Building Over/Adjacent to Public Sewers - Building Regulations 2010 (as amended).
Location: 8 Campbell Road, Eastleigh, Hampshire, SO50 5AD.

Thank you for the revised plans, drawing no 3062-EVE-1B-XX-DR-S-0200 Rev L and K.

Drawing Title PROPOSED GROUND AND MEZZANINE GENERAL ARRANGEMENT				
Drawn by AO		Checked by KT		Scale @A1 As indicated
Drawing No. 3062-EVE-1B-XX-DR-S-0200				Revision K
Consulting Structural & Civil Engineers 20 Baltic Street, London, EC1Y 0UL W: www.evolveuk.biz E: info@evolveuk.biz T: 0207 251 6888

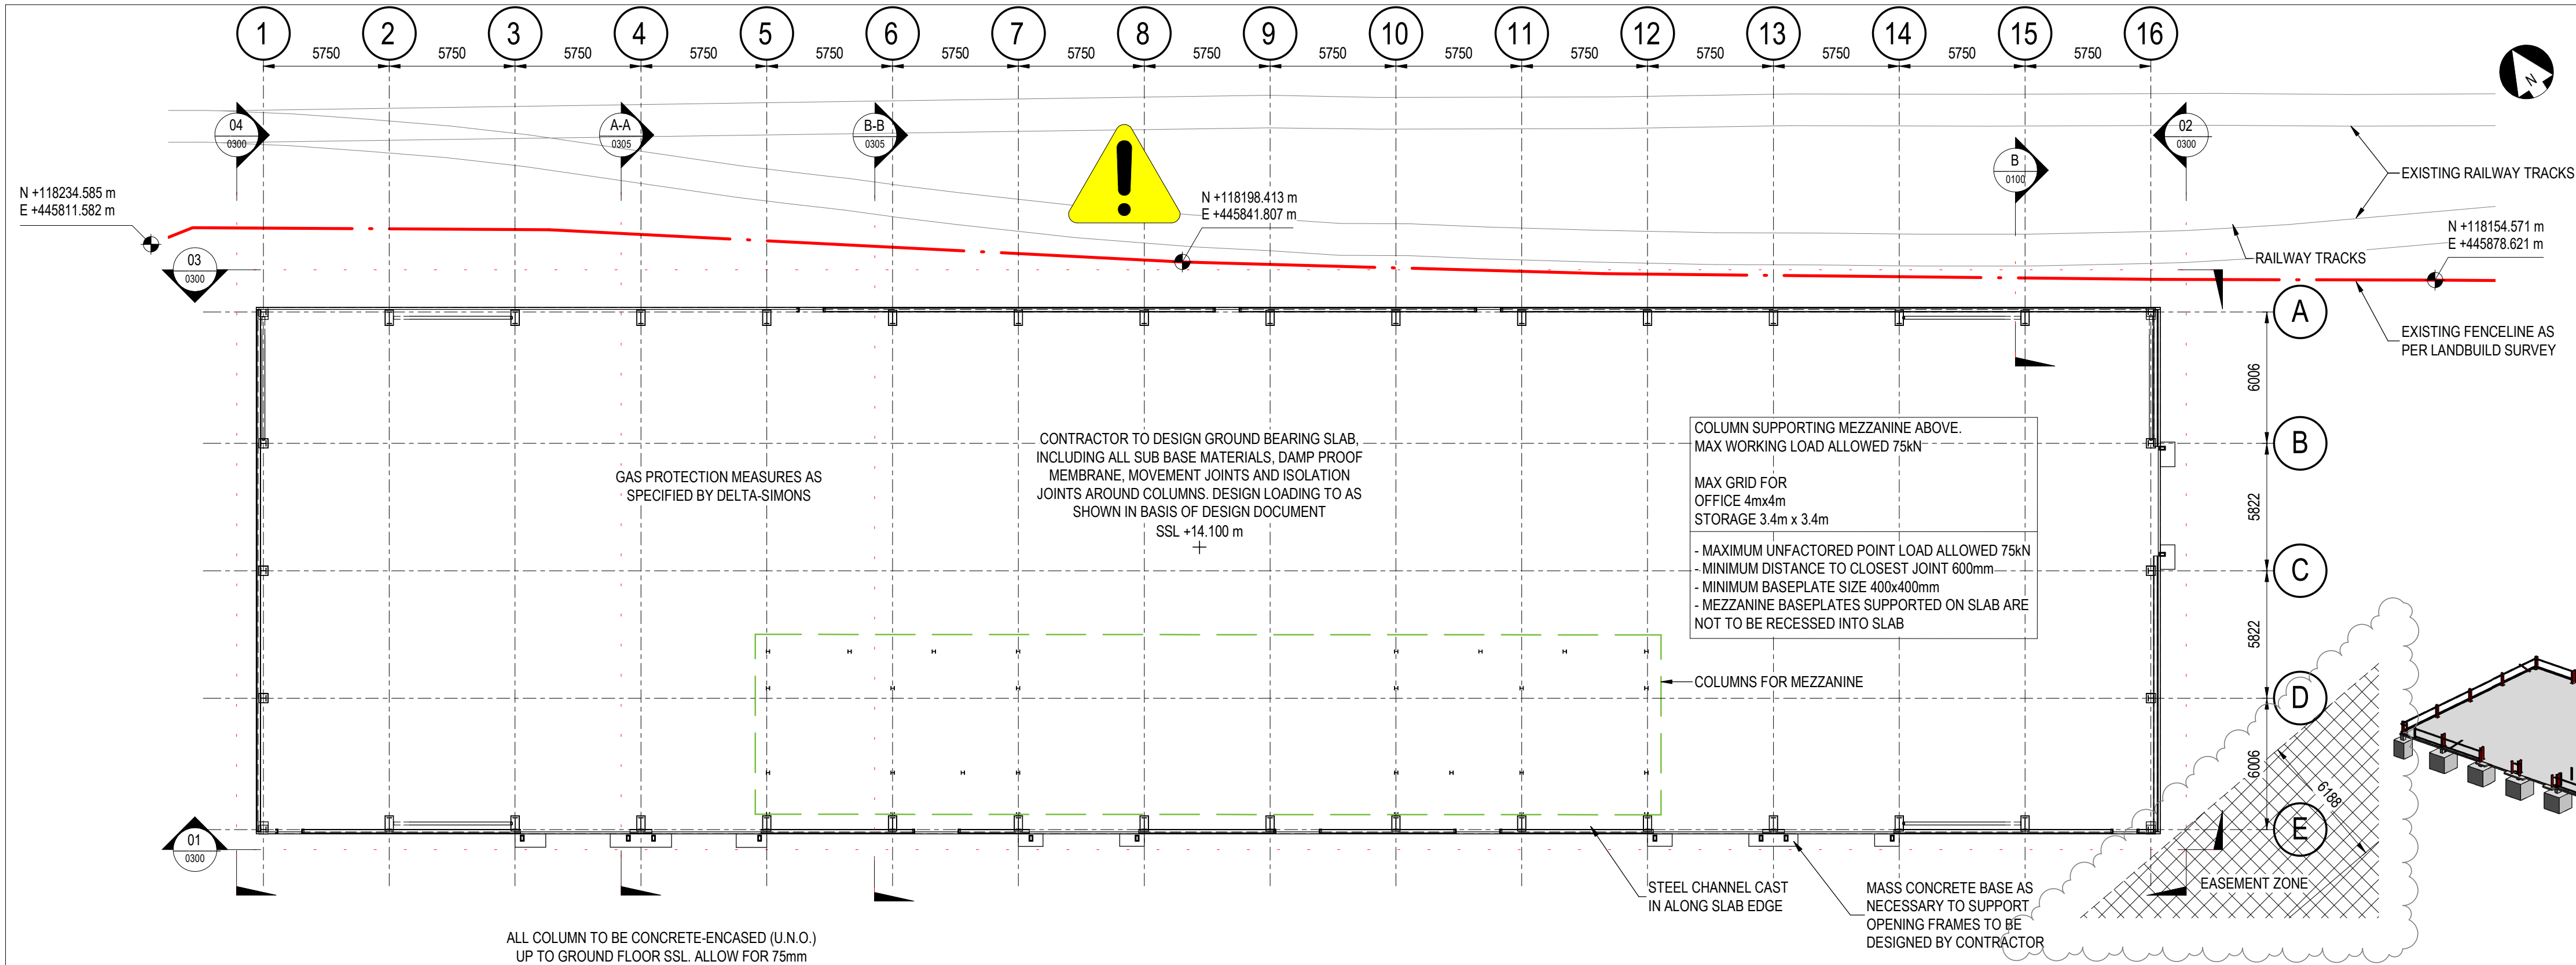
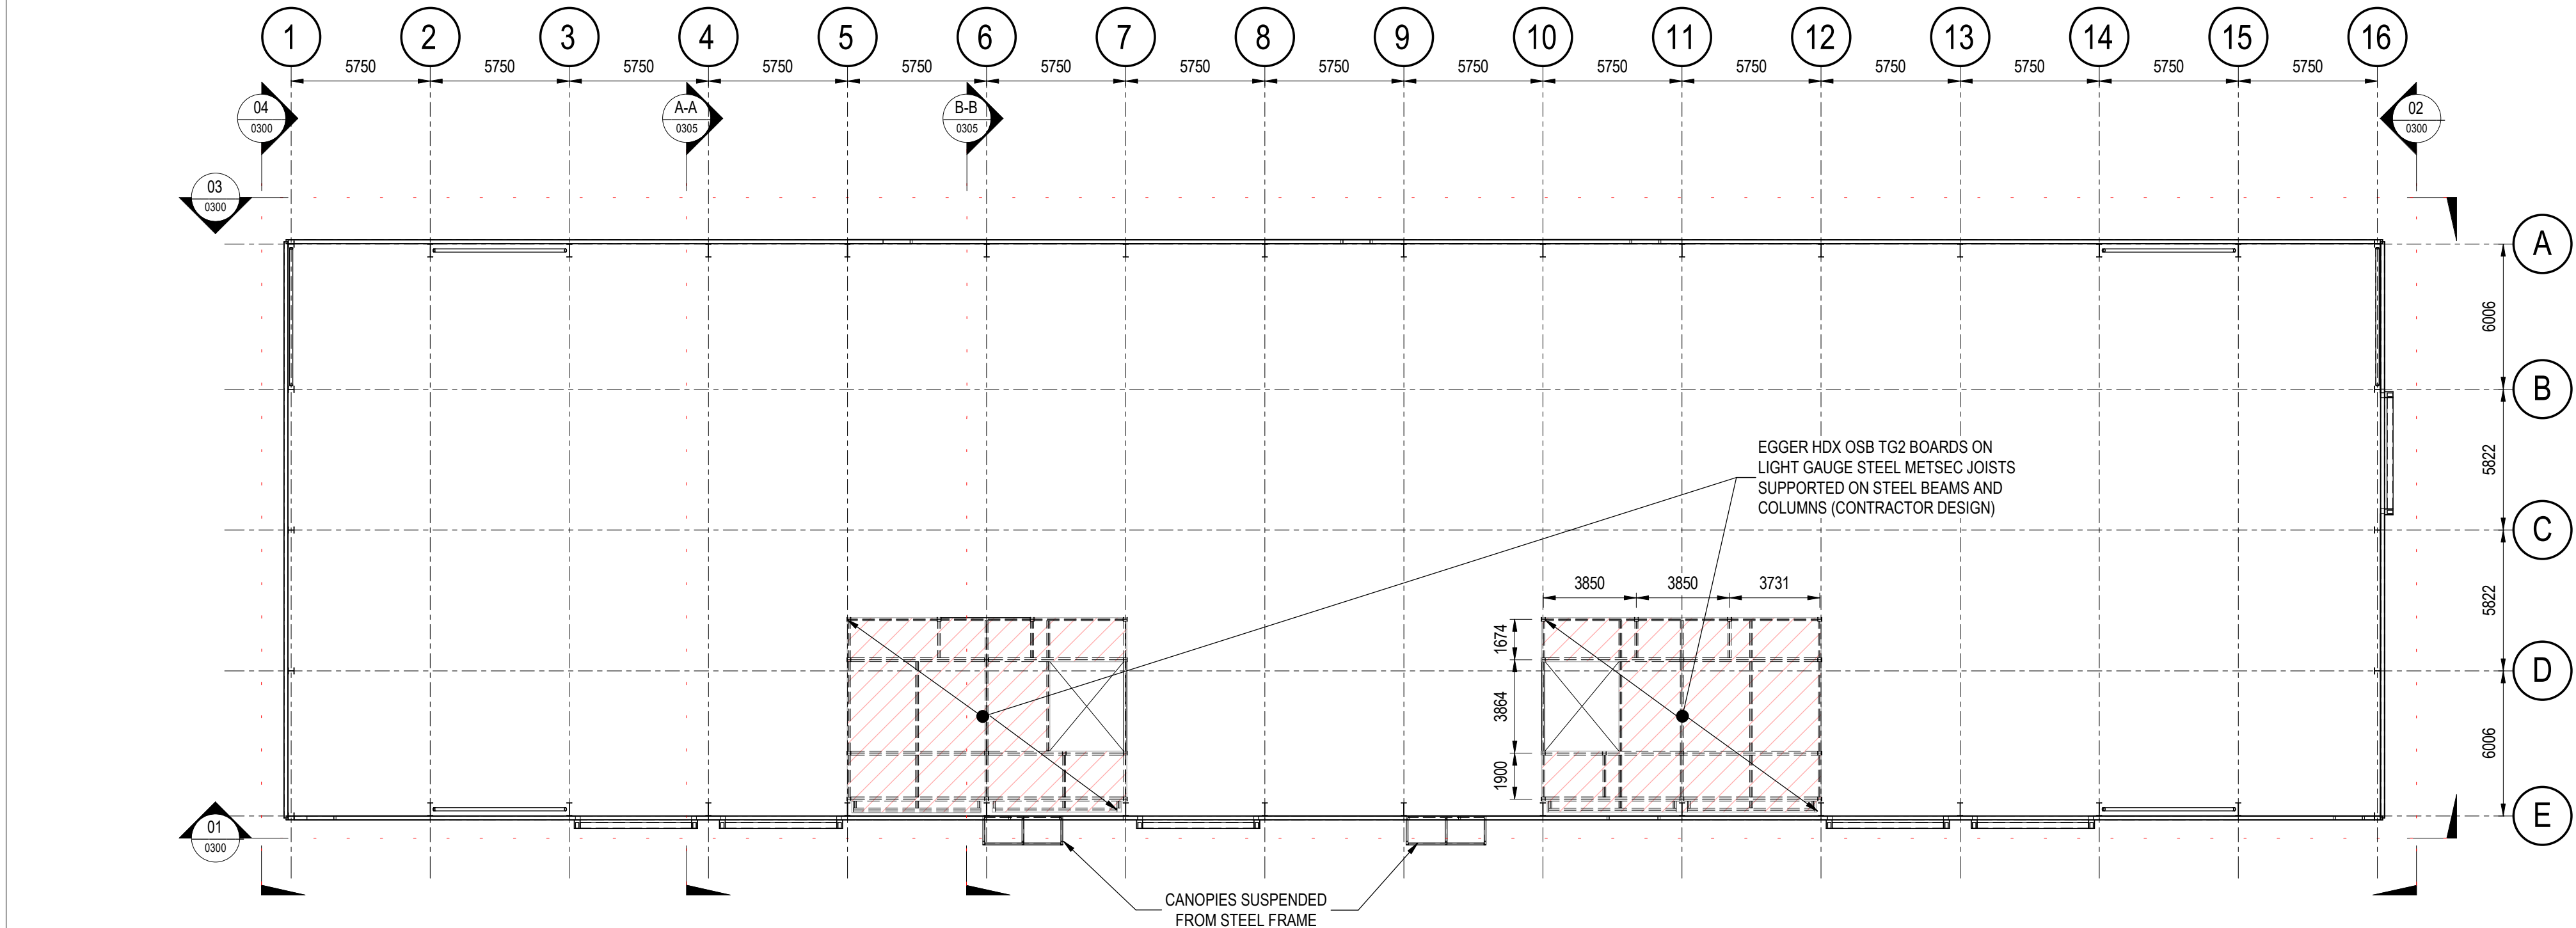
After reviewing your application, the revised plans and the CCTV survey that was carried out to locate and inspect the condition of the sewer/s affected by your proposed new building works, at the above site address. We are prepared to grant conditional approval to build over/near the public sewer at this address. This is not an approval of your proposed plans but an approval to build near the sewer subject to you meeting the following conditions:

1. No structure (footings, walls etc) running **within 6.00m** from the existing public **375 vitrified clay (VC) critical (by depth as well as diameter) foul sewer/manholes will be permitted.**

2. The foundations must be taken down to a minimum depth of 150mm below the invert level of the sewer/manhole. The depth of the sewer is approximately 6.20m below ground level at the time of survey.

3. Southern Water does not permit internal public manholes, a new extension to be built over or within 500mm of public sewer pipes, or where there is a change-in-direction of pipework (sewer/manhole).
